COMMITTEE OF THE WHOLE OCTOBER 4, 2011

**ZONING BY-LAW AMENDMENT FILE Z.11.024
SITE DEVELOPMENT FILE DA.11.072
CASERTANO DEVELOPMENT CORP. (PHASE 1)
WARD 4**

Site Plan

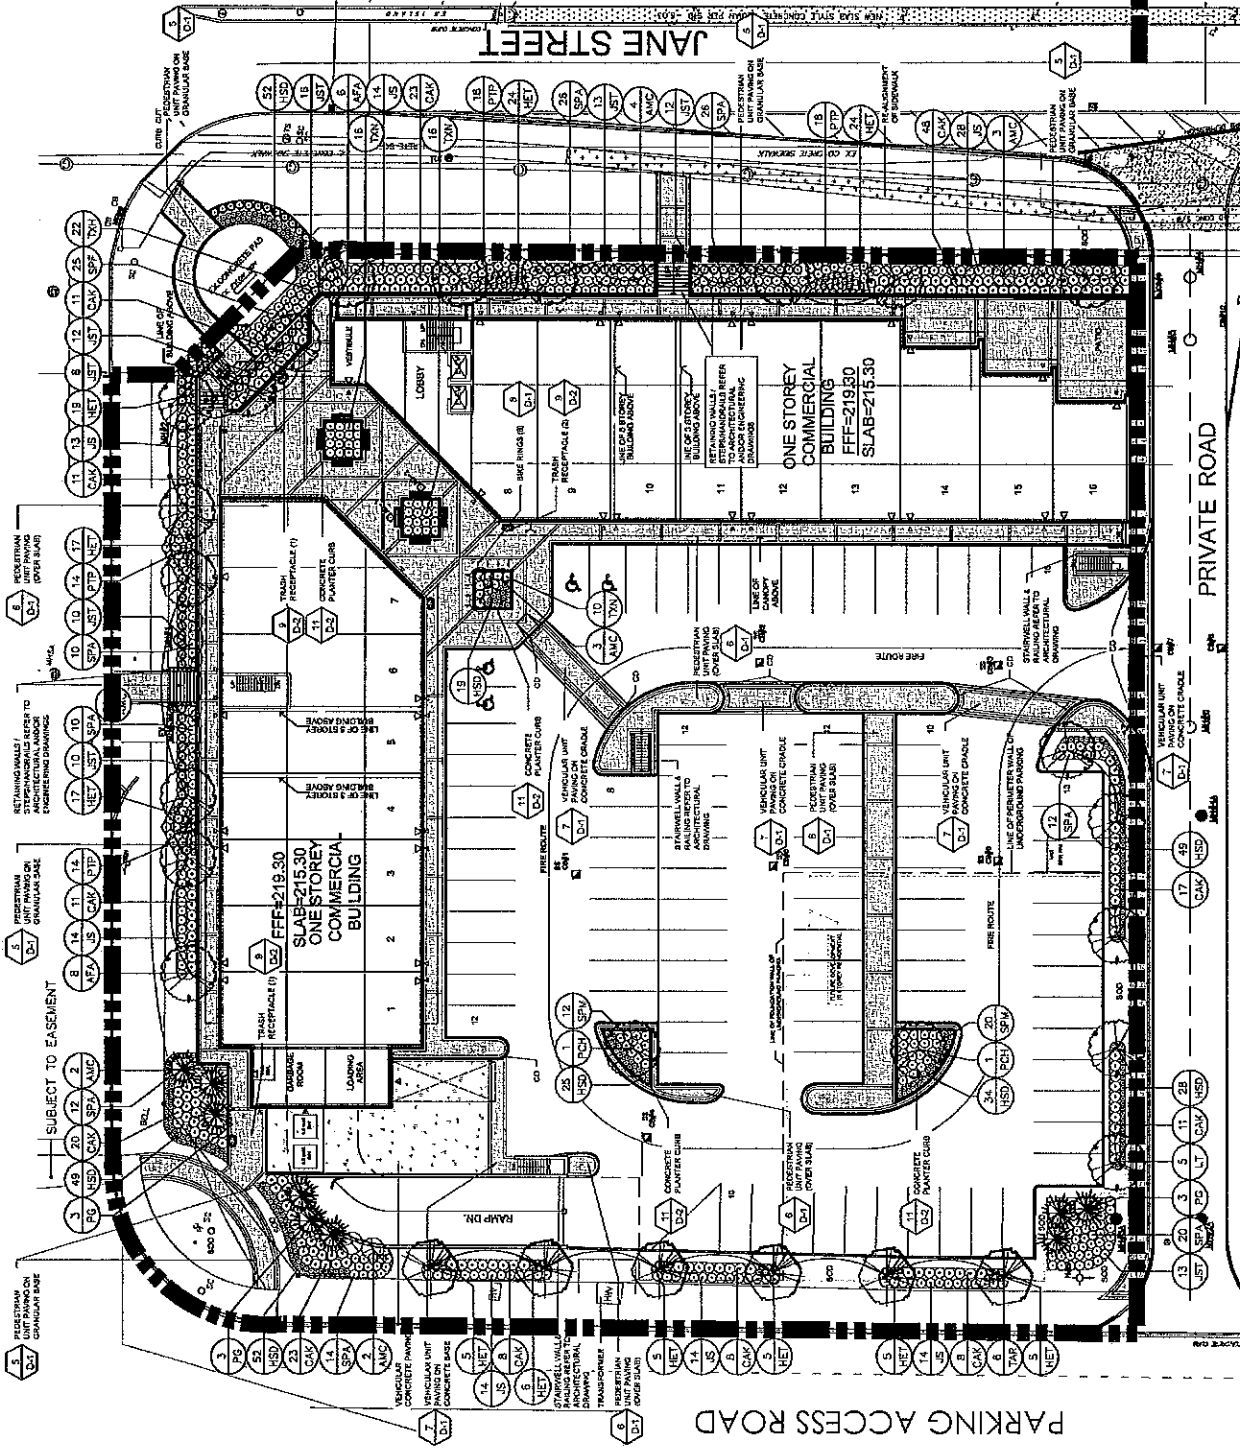
- a) the street wall massing should be articulated up with evenly spaced vertical recesses or other articulations and/or changes in the building materials;

- b) the ground floor commercial interface along Jane Street should include street related active facades with vision glazing and primary entrances at grade flush with the adjacent public sidewalks;

- c) the site should include grade related landscaped pedestrian accessibility to public transit;
- d) phasing plans for the site must be submitted for the site and underground parking to demonstrate the feasibility of the site plan concept;

- e) activate the rooftop of the proposed one-storey portions of the building for uses such as outdoor patios for the commercial units. This can be achieved by considering direct vertical access points to the rooftop patios from the adjacent walkways and the parking area;

- f) increase the amount and quality of landscaped areas and pedestrian areas; and,
- g) the south end of the building should be setback further from the private road.
